# Addendum No. 06

April 11, 2024

## BAKERSFIELD COLLEGE STUDENT HOUSING (for DSA Project Name - New Residence Hall)

**PBK PROJECT NO.:** S2103400AR  
**DSA FILE NO.:** 15-C1  
**DSA APPLICATION NO.:** 02-122124

AX3.1

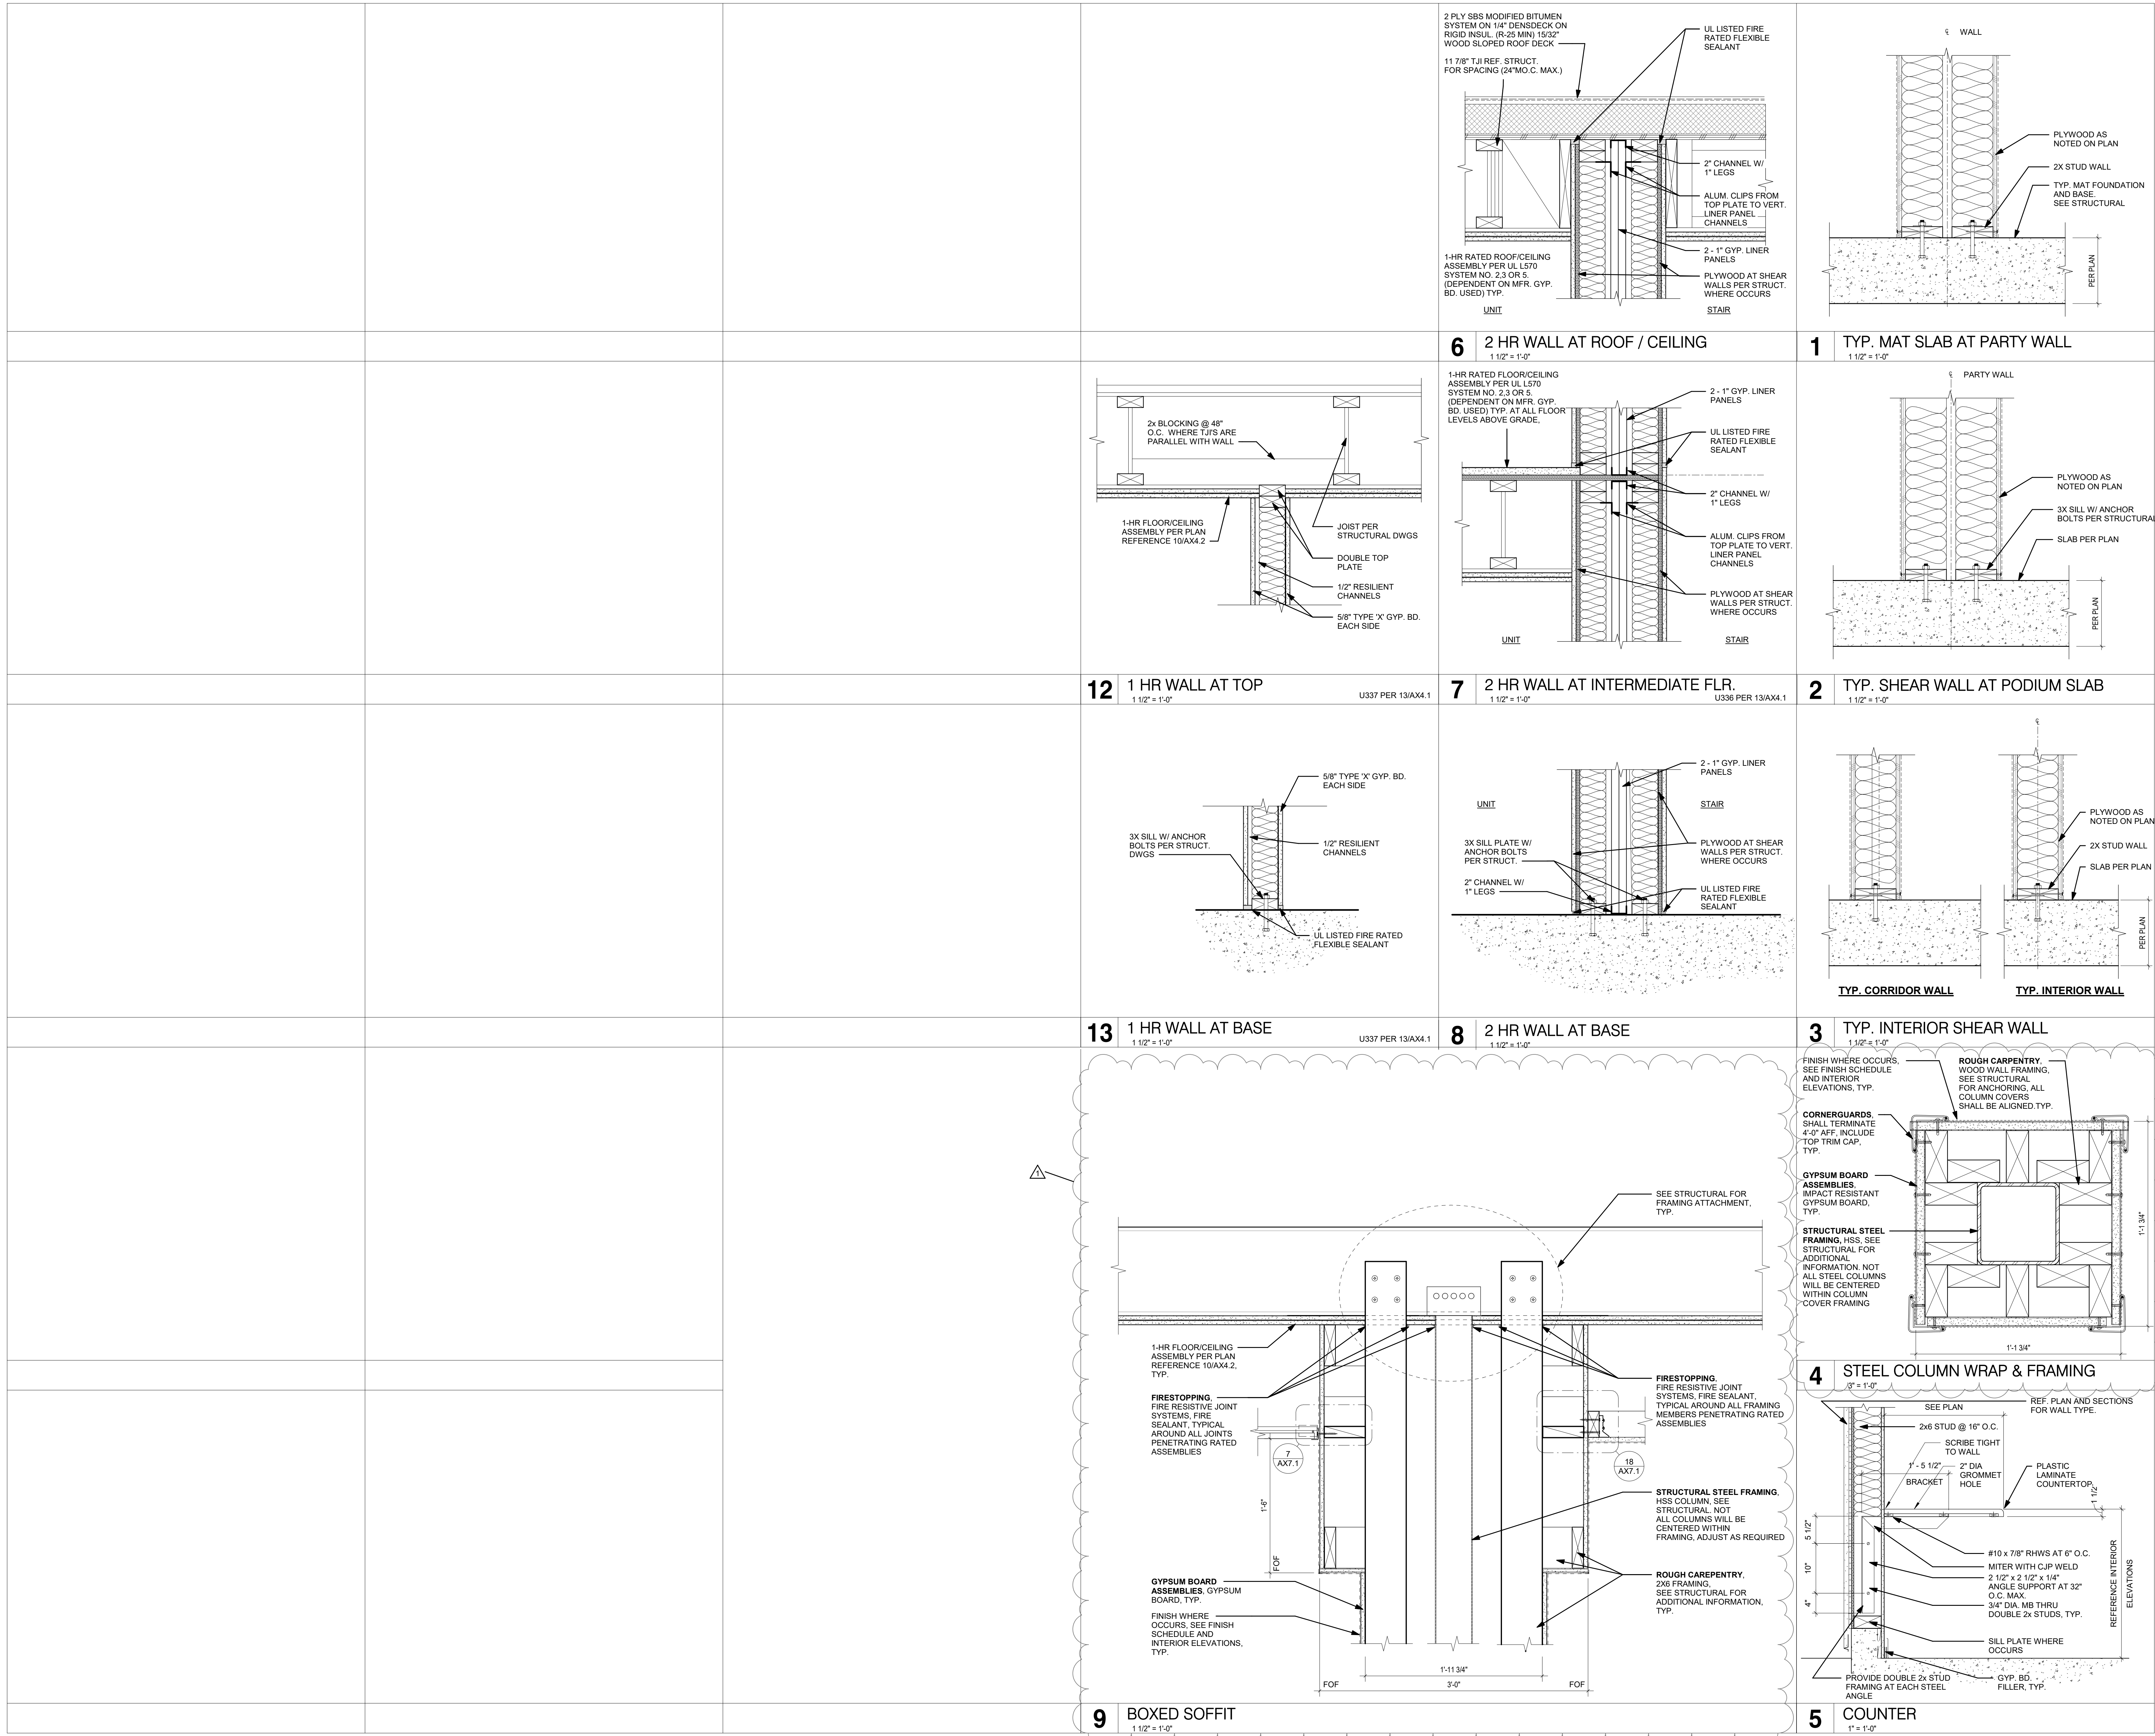
- AD6-29**    **AX3.1 – Door and Frame Details:** Replace the sheet in its entirety. Added detail 24. See attached revised drawing AX3.1 with all changes clouded.

2.02	03/11/24	Detail 1/AX3.1 shows a wood head and casing while door schedule calls out for hollow metal. Is there an alternate detail?	S.C. Anderson Inc.	Refer to addendum No 6	PBK	11-Apr

2.03	03/11/24	Detail 6/AX3.1 shows a wood head and casing while door schedule calls out for hollow metal. Is there an alternate detail?	S.C. Anderson Inc.	Refer to addendum No 6	PBK	11-Apr

2.04	03/11/24	Door 239B detail 7/AX3.1 shows a storefront head while door schedule calls out for hollow metal. Is there an alternate detail?	S.C. Anderson Inc.	Refer to addendum No 6	PBK	11-Apr

**L1.1**

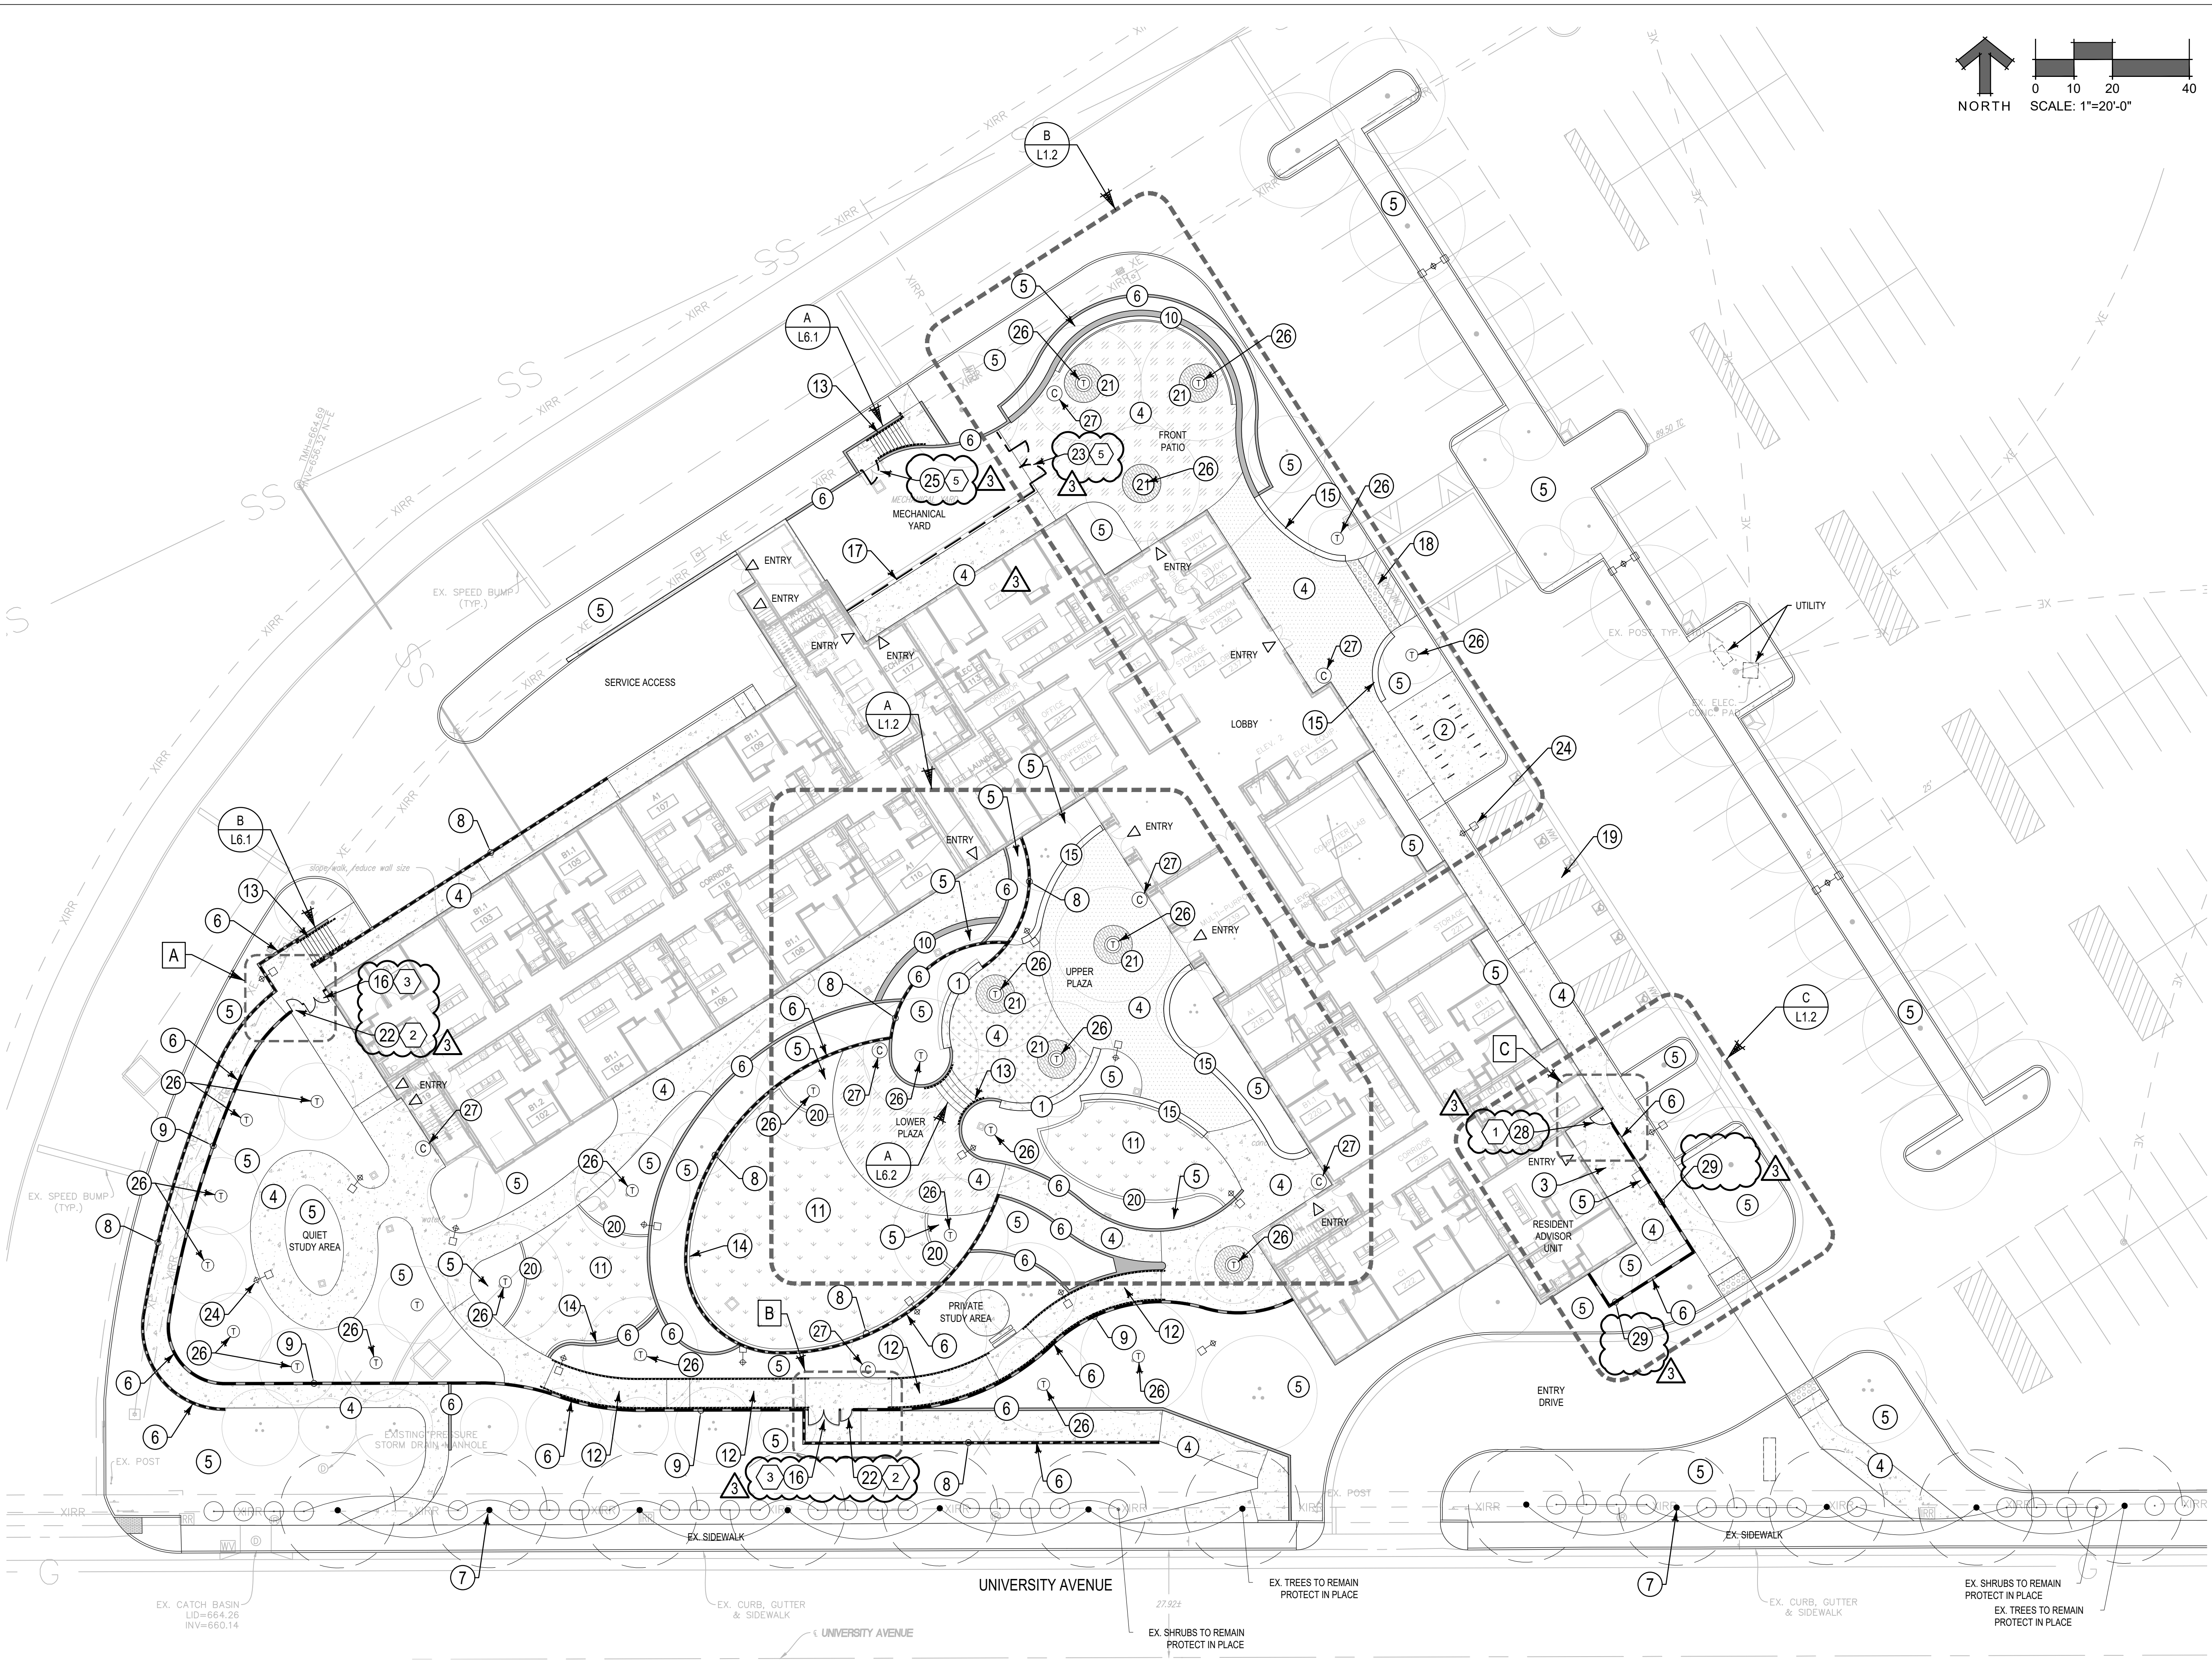
- AD6-31**    **L1.1 – SITE PLAN:** Replace the sheet in its entirety. Revised legend and added gates. See attached revised drawing L1.1 with all changes clouded.
- AD6-32**    **L1.2 – SITE PLAN - ENLARGEMENTS:** Replace the sheet in its entirety. Revised patio control joints. See attached revised drawing L1.2 with all changes clouded.
- AD6-33**    **L1.3 – SITE PLAN – PAVING FINISHES:** Replace the sheet in its entirety. See attached revised drawing L1.3 with all changes clouded.
- AD6-34**    **L2.1– IRRIGATION PLAN TREES AND SHRUBS:** Replace the sheet in its entirety.

BID  
**MECHANICAL ENLARGED FLOOR PLAN - LEVEL 02 - NORTH**  
**M1.22**

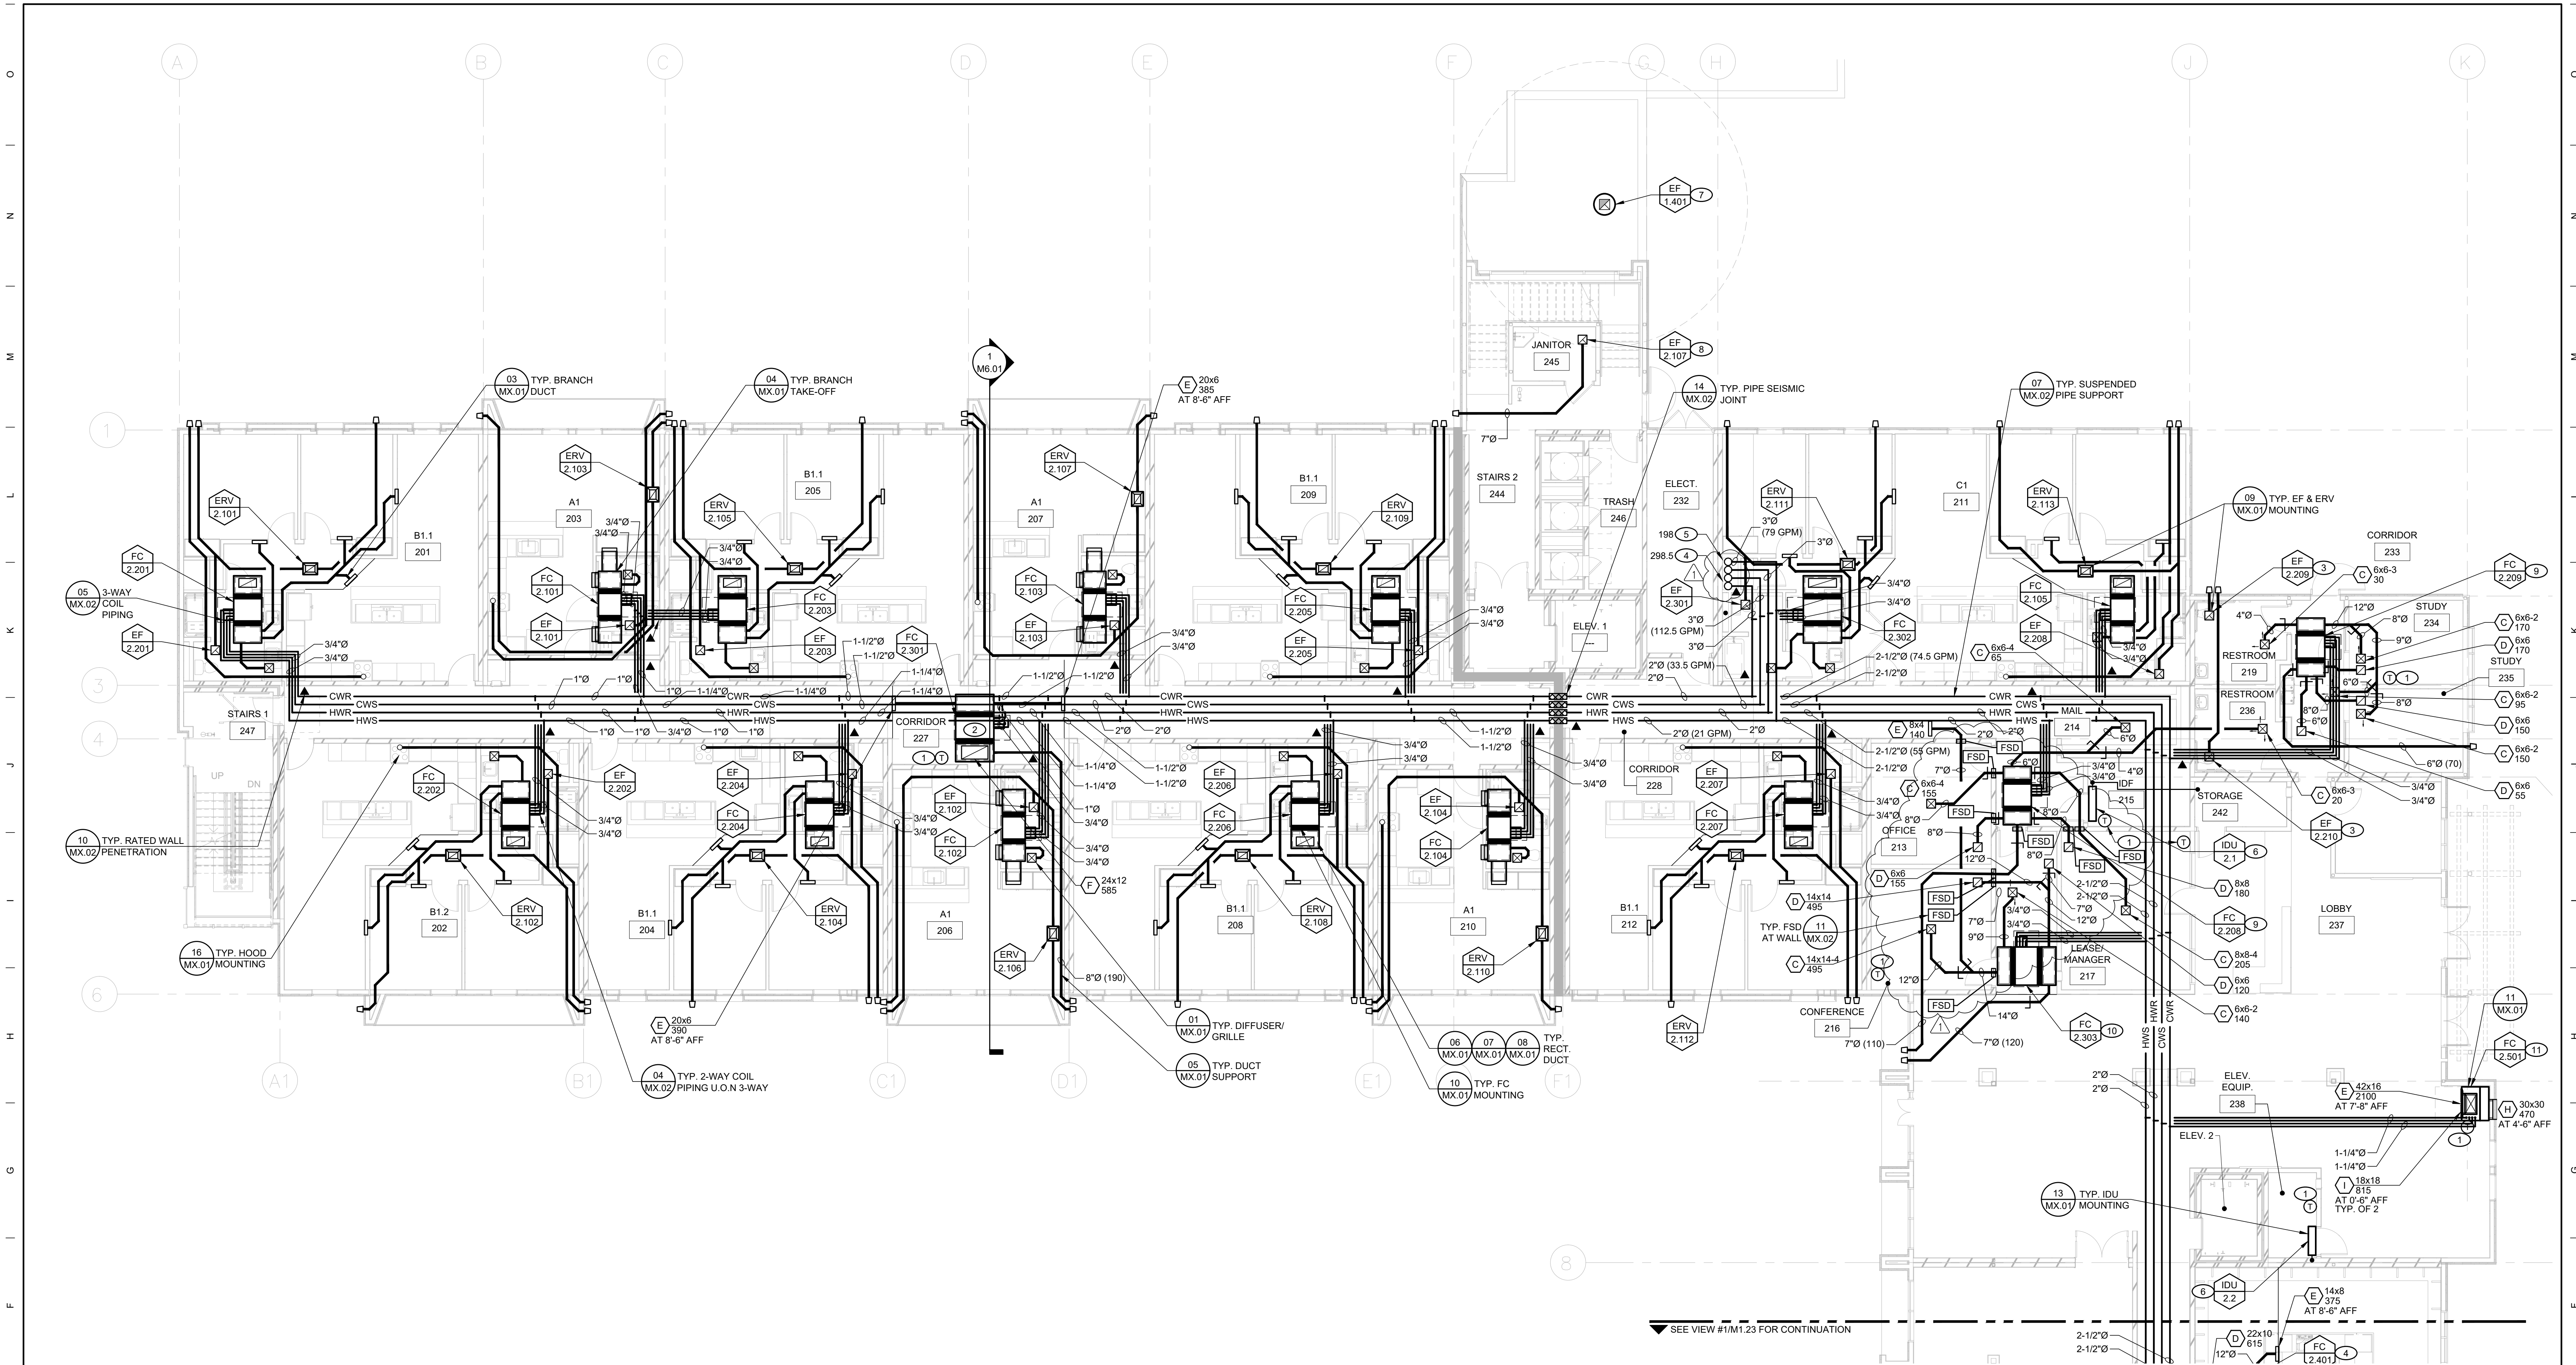
- AD6-39 M1.22 – MECHANICAL ENLARGED FLOOR PLAN – LEVEL 02 - NORTH: ADD** Fire/ Smoke Dampers and fire stopping at hydronic piping into chase. See attached revised drawing M1.22 with all changes clouded.
